UNITED STATES PATENT AND TRADEMARK OFFICE

APPLICATION NO.	FILING DATE	FIRST NAMED INVENTOR	ATTORNEY DOCKET NO.	CONFIRMATION NO.
10/786,348	02/24/2004	Scott J. DeBoer	1999-1335.01/US	4548

Office Action Summary	Application No. 10/786,348	Applicant(s) DEBOER ET AL.	
	Examiner Hoai v. Pham	Art Unit 2814

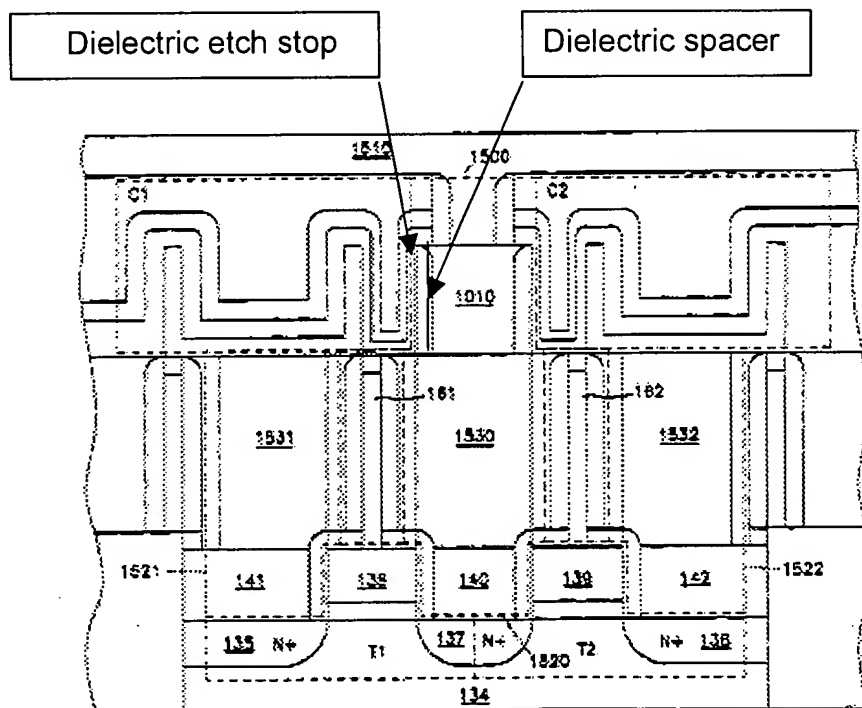
5. Claims 6 and 21-22 are rejected under 35 U.S.C. 103(a) as being unpatentable over Noble [U.S. Pat. 6,190,960] previously applied.

Noble does not teach the height range of the receptacle and the capacitor top plate, as claimed by Applicant. However, the height range would have been obvious to an ordinary artisan practicing the invention because, absent evidence of disclosure of criticality for the range giving unexpected results, it is not inventive to discover optimal or workable ranges by routine experimentation. *In re Aller*, 220 F.2d 454, 105 USPQ 233, 235 (CCPA 1955). Furthermore, it appears that these changes produce no functional differences and therefore would have been obvious. See *In re Woodruff*, 919 F.2d 1575, 1578, 16 USPQ2d 1934, 1936 (Fed. Cir. 1990).

6. Applicant's arguments filed 3/10/2005 have been fully considered but they are not persuasive.

Applicant's argument are not persuasive because the claim does not recite the different material between the dielectric etch stop liner and the dielectric spacer. Therefore, the dielectric etch stop liner and the dielectric spacer can be considered as one layer.
